Project	IEEE 802.16 Broadband Wireless Access Working Group < http://ieee802.org/16 >
Title	Add New Primitive on MS Handover Management diagrams
Date Submitted	2006-03-01
Source(s)	<p style="text-align: right;">jqian@ztesandiego.com</p> <p>Jeff Qian Cancan Huang Mary Chion Sean Cai Xu Ling ZTE</p>
Re:	Contribution on comments to P802.16g-D1
Abstract	In this contribution, we propose to add C-HO-NOTFY(HO-CMPLT) primitive in Figure 499 and Figure 500
Purpose	Adoption
Notice	This document has been prepared to assist IEEE 802.16. It is offered as a basis for discussion and is not binding on the contributing individual(s) or organization(s). The material in this document is subject to change in form and content after further study. The contributor(s) reserve(s) the right to add, amend or withdraw material contained herein.
Release	The contributor grants a free, irrevocable license to the IEEE to incorporate text contained in this contribution, and any modifications thereof, in the creation of an IEEE Standards publication; to copyright in the IEEE's name any IEEE Standards publication even though it may include portions of this contribution; and at the IEEE's sole discretion to permit ot

Figure 499 ----HO primitives flow between Serving BS and NCMS, BS initiated

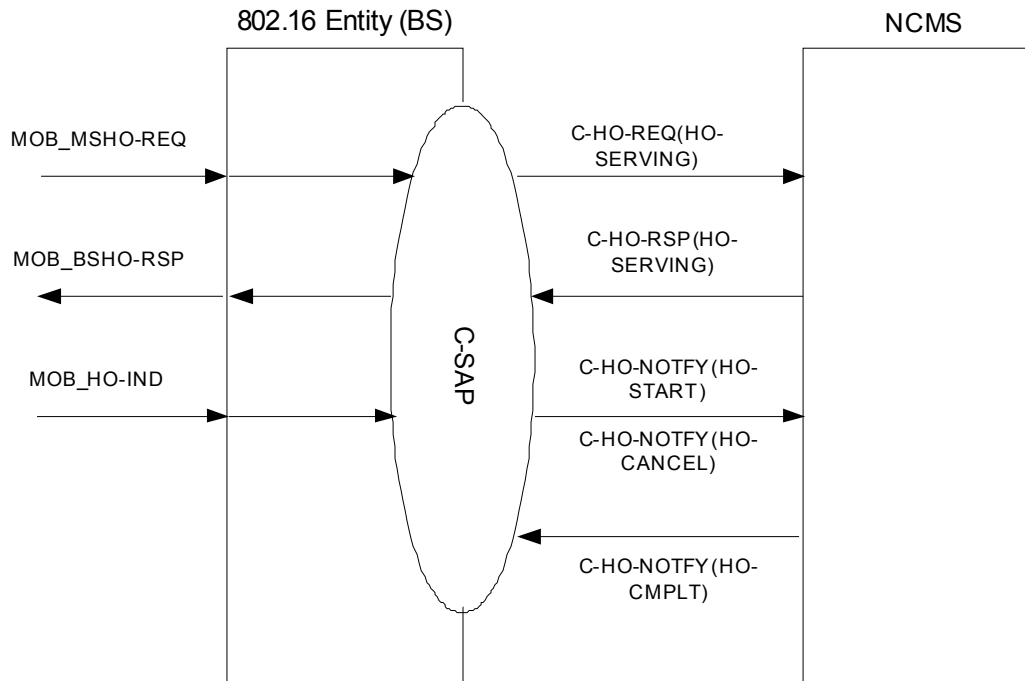
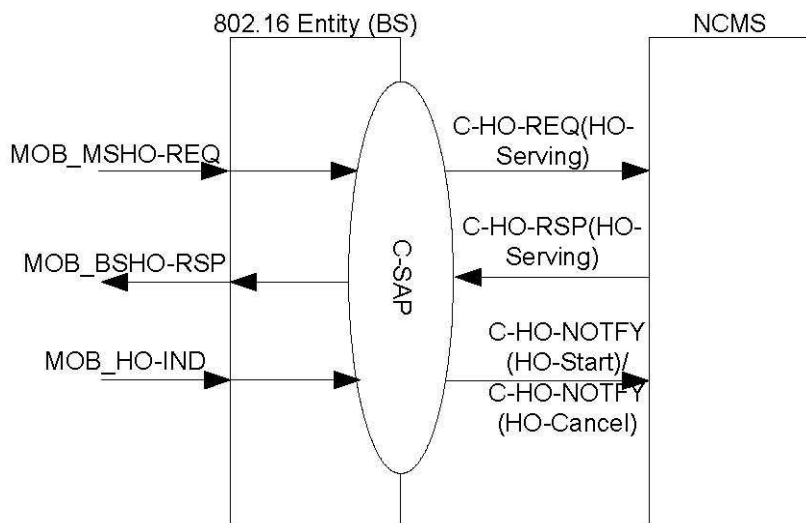
In Section 14.2.9.7 (Handover Control Protocol Procedures), Figure 499 and Figure 500 have missed primitive C-HO-NOTFY(HO-CMPLT) from NCMS to BS. This primitive should be used to release resources from serving BS after handover procedure has completed.

This contribution proposes to add C-HO-NOTFY (HO-CMPLT) primitive in Figure 499 and Figure 500 in section 14.2.9.7. It also modified the corresponding text in section 14.2.9.7.3.4. Subsection 14.2.9.7.3.4.3.1, 14.2.9.7.3.4.3.2, 14.2.9.7.3.4.4.1 and 14.2.9.7.3.4.4.2 have been added accordingly.

[Modify section 14.2.9.7, replace Figure 499 and 500 with the following figures]
